STATE OF NORTH CAROLINA  
DEPARTMENT OF TRANSPORTATION

April 13, 2006

Subject: **Additional Information for Section 401 Water Quality Certification/Neuse Buffer Certification and Section 404 Nationwide Permits 14 & 33** for US 1/64 From US 64/SR 1009 (Tryon Road) Interchange to South of I-40 in Cary, Wake County; **TIP No. U-3101C & D**; State Project No. 8.1403101; Federal Aid Project No. STPNHF-1(4); USACE Action ID Nos. 200120922 & 200421562; NCDENR-DWQ Project No. 041055; WBS Element 34897.1.1.

5 0 10	PROJECT REFERENCE NO. U-3101C&D	SHEET NO. 8
	R/W SHEET NO.	
	ROADWAY DESIGN ENGINEER NORTH CAROLINA PROFESSIONAL SEAL 14493	HYDRAULICS ENGINEER NORTH CAROLINA PROFESSIONAL SEAL 22100
	CONST. REV. 3-31-06 R/W REV.

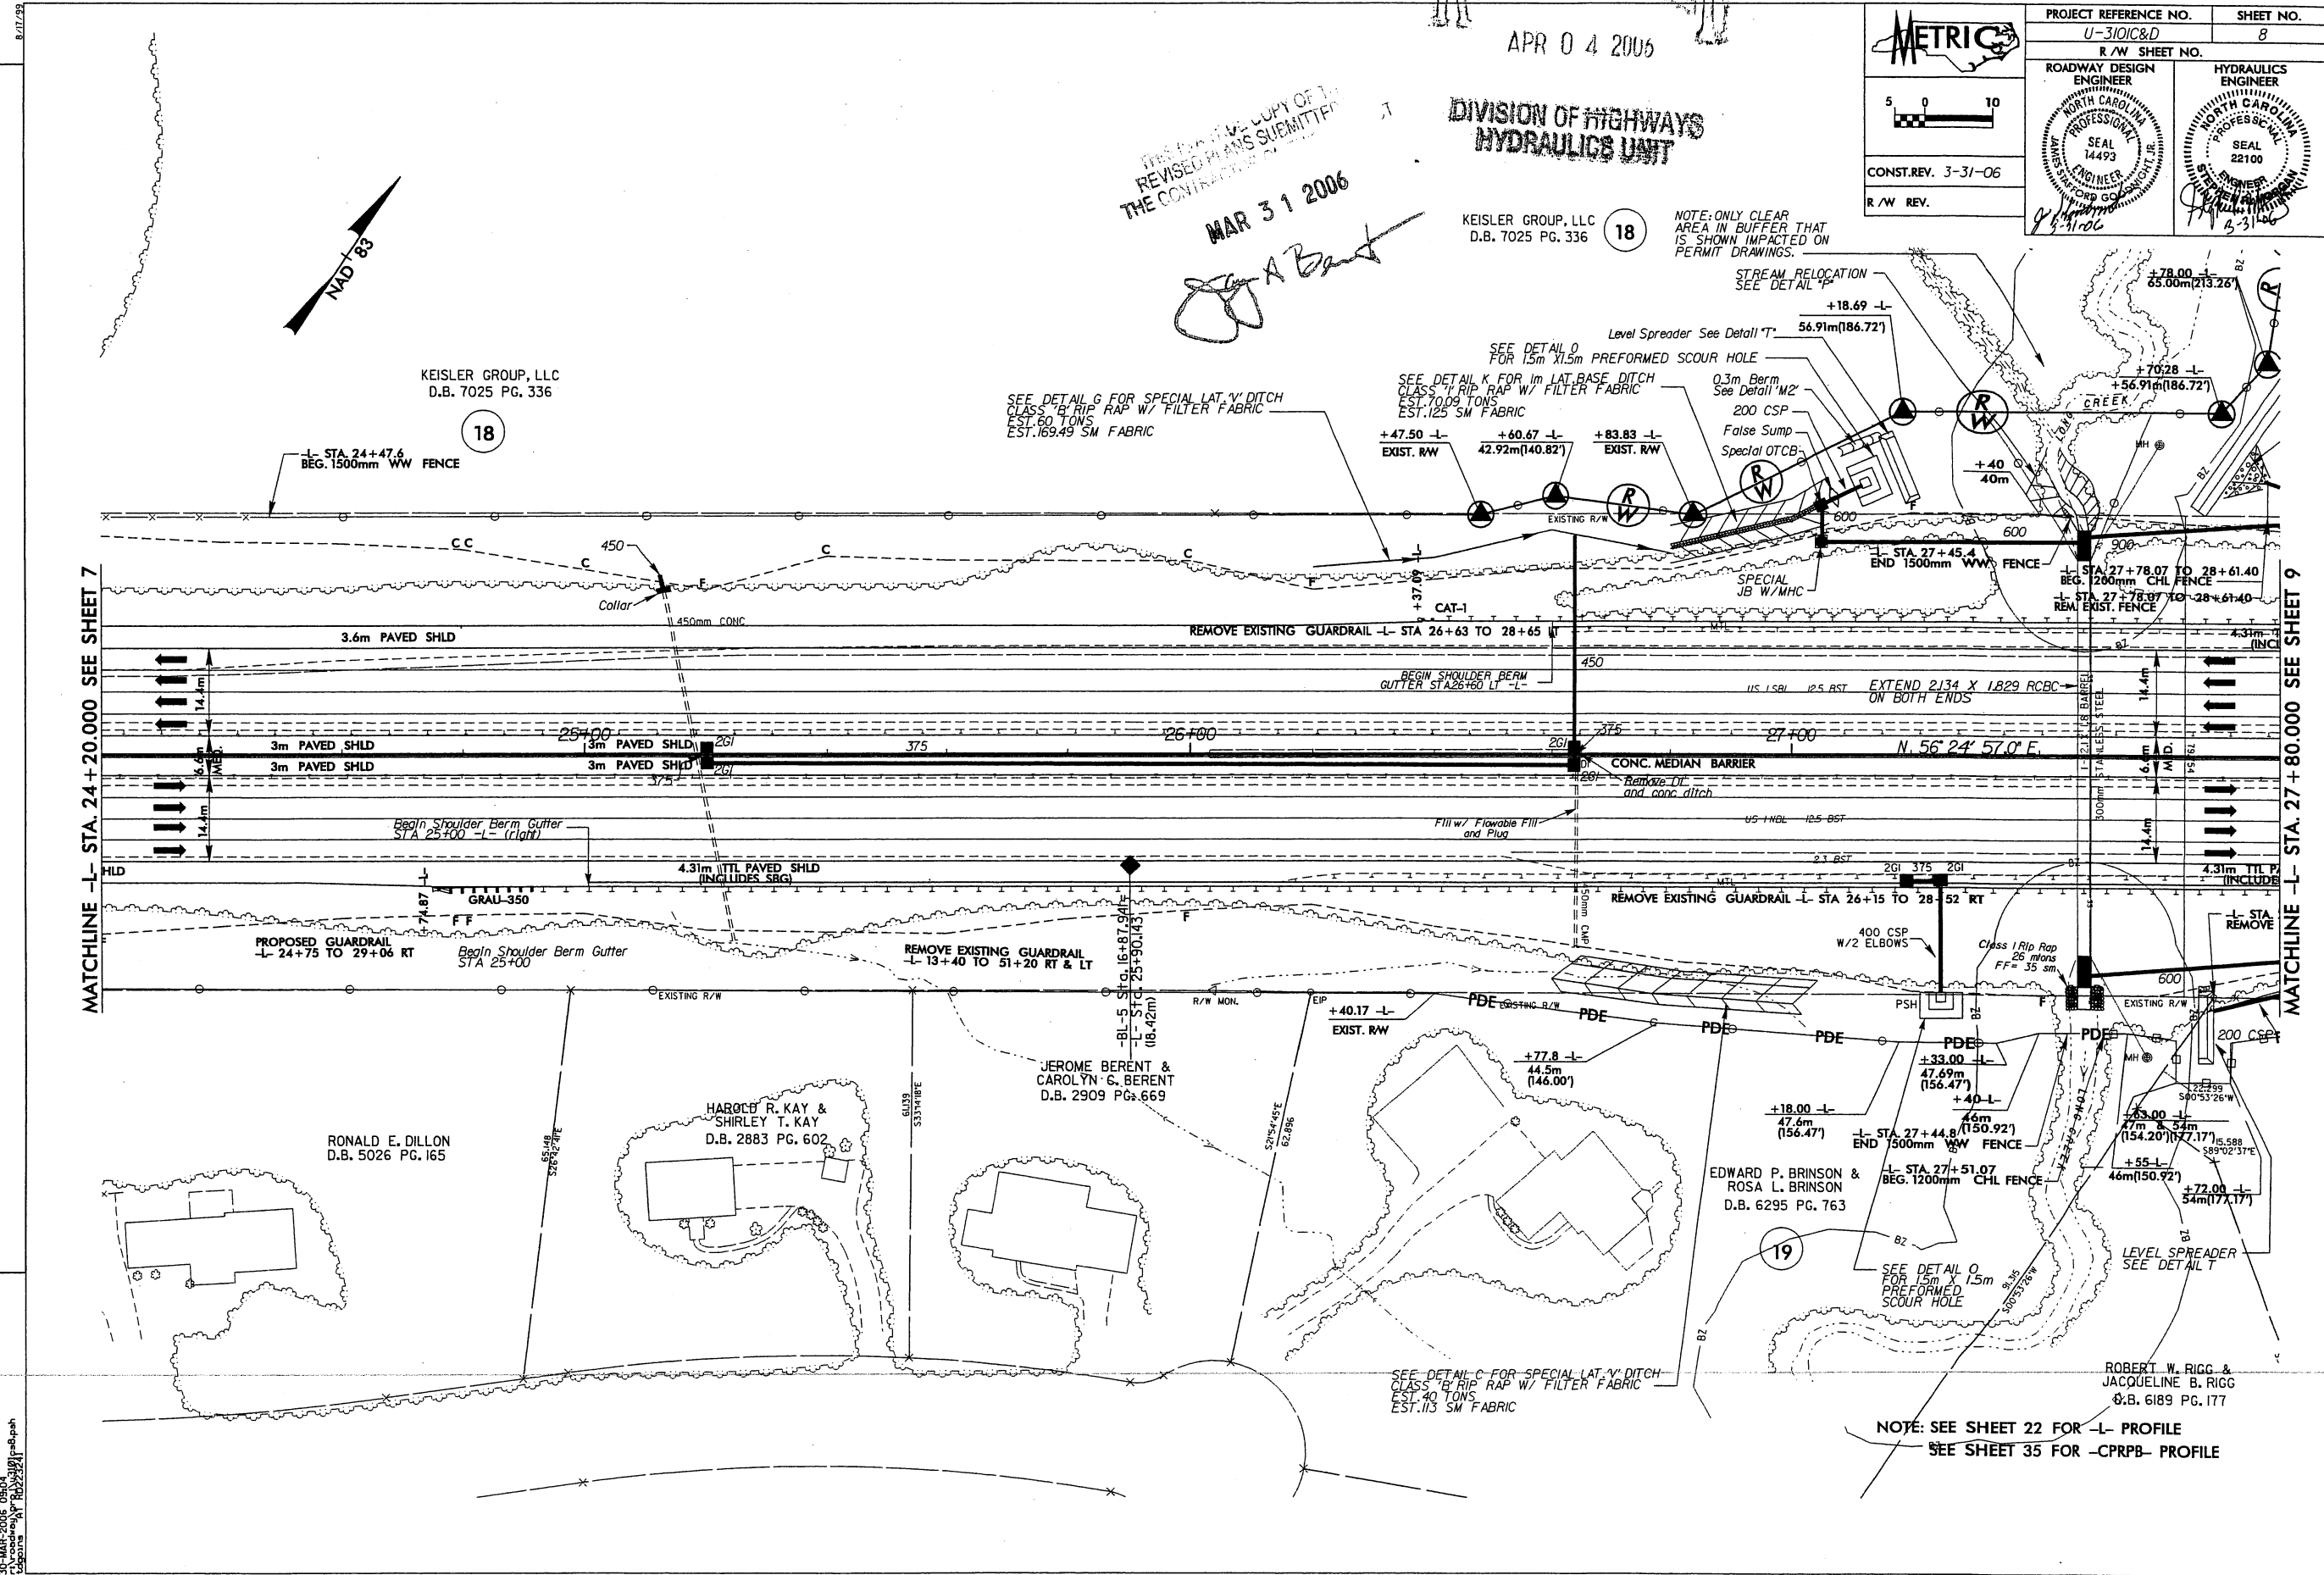
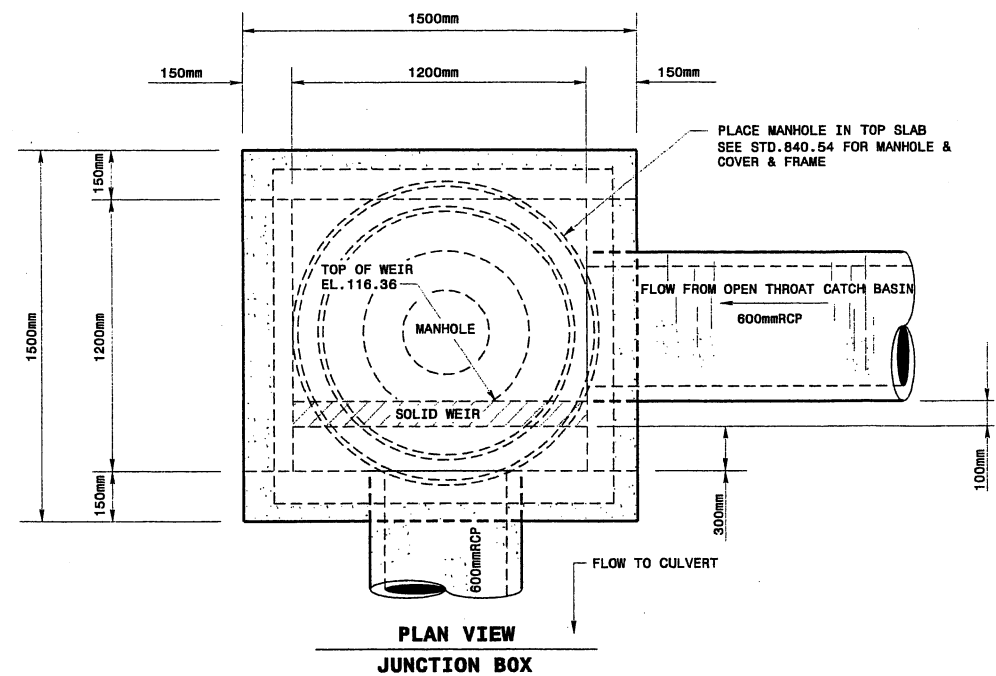
REVISIONS  
LEVEL SPREADER ADDED 27+20 LT.; 450mm PIPE OUTLET ADDED (26+63 LT.); EXISTING 450mm ABANDONED (26+63 RT.); W.D.P. OUTLET REV. 27+80 LT. SRM 3-31-06

**SPECIAL JUNCTION BOX AND OPEN THROAT CATCH BASIN  
STA. 27+05-L- LT.**

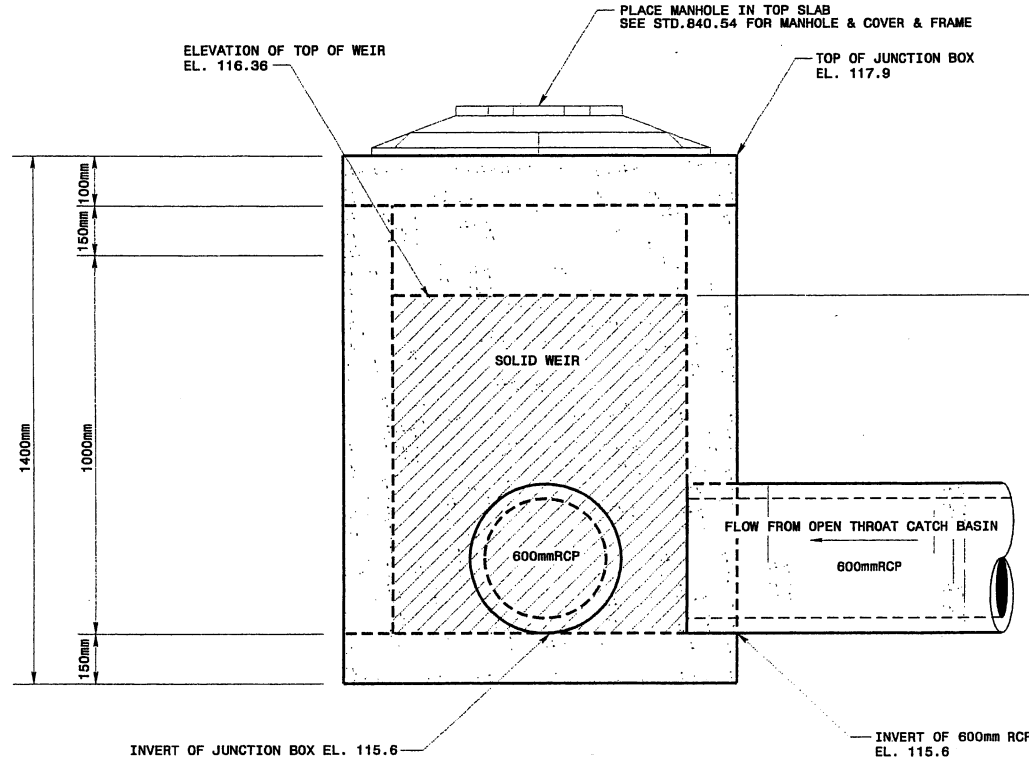
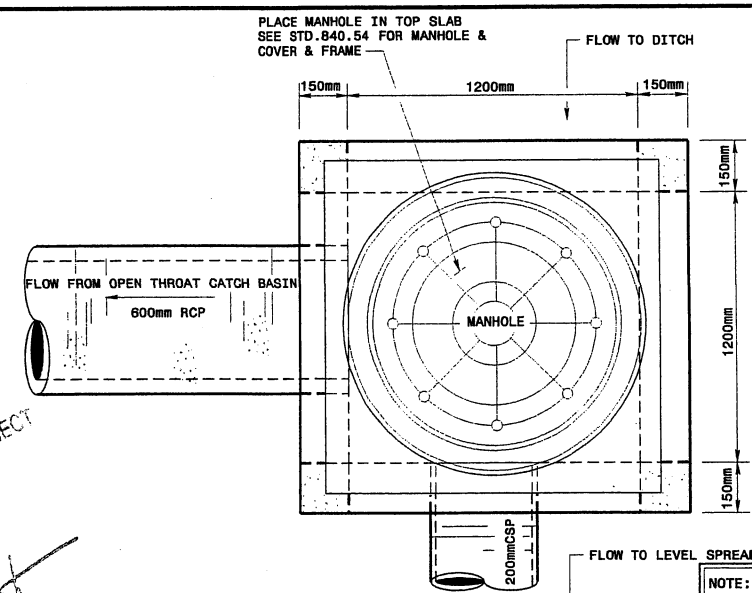
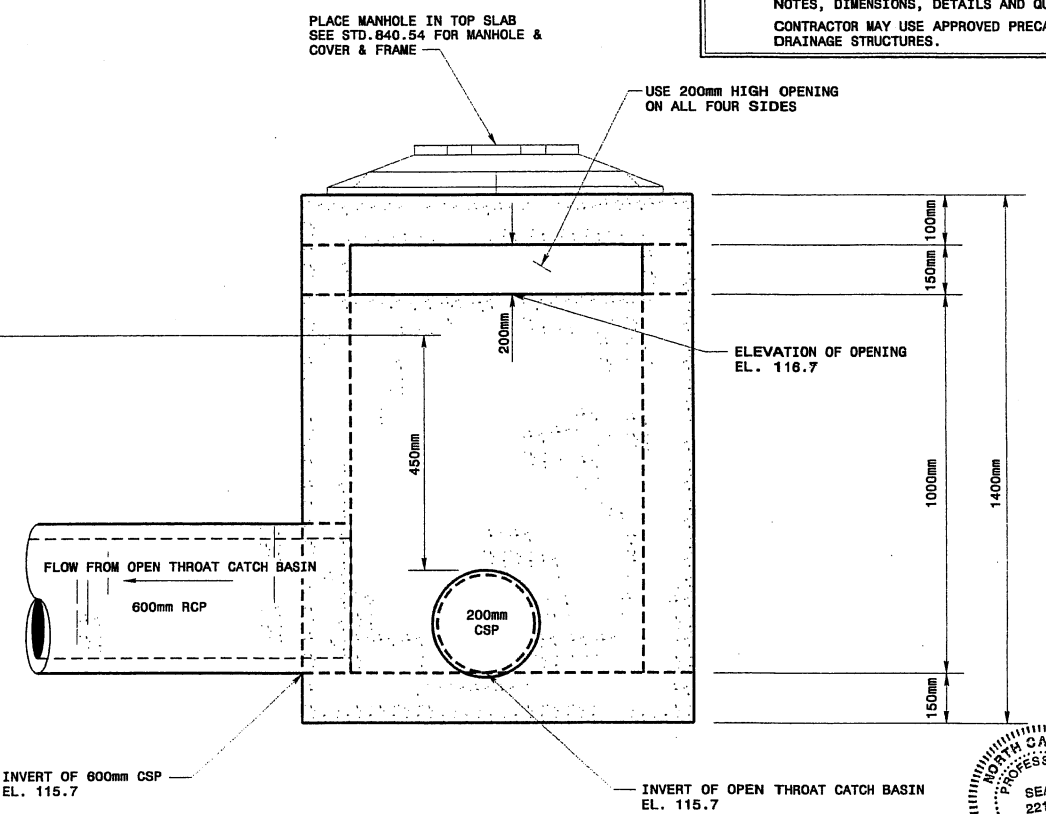
NOTE: ELEVATIONS SHOWN MAY VARY DEPENDING ON ACTUAL FIELD ELEVATIONS. DIMENSIONS SHOULD NOT VARY.  
\* CRITICAL DIMENSIONS: TOP OF WEIR NEEDS TO BE 450mm ABOVE TOP OF 200mm CSP SEE STD. NO. 840.04 FOR DRAINAGE STRUCTURE NOTES, DIMENSIONS, DETAILS AND QUANTITIES. CONTRACTOR MAY USE APPROVED PRECAST CONCRETE DRAINAGE STRUCTURES.

PROJECT REFERENCE NO. U-3101C&D	SHEET NO. 2-UU
R/W SHEET NO.	
ROADWAY DESIGN ENGINEER	HYDRAULICS ENGINEER
CONST. REV. 3-31-06	
R/W REV.

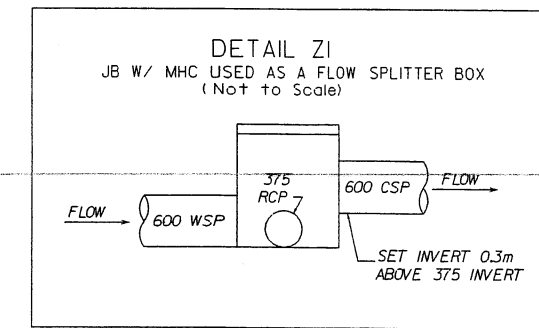
DET. 'M' STATIONS REVISED BY SRM 3-31-06.
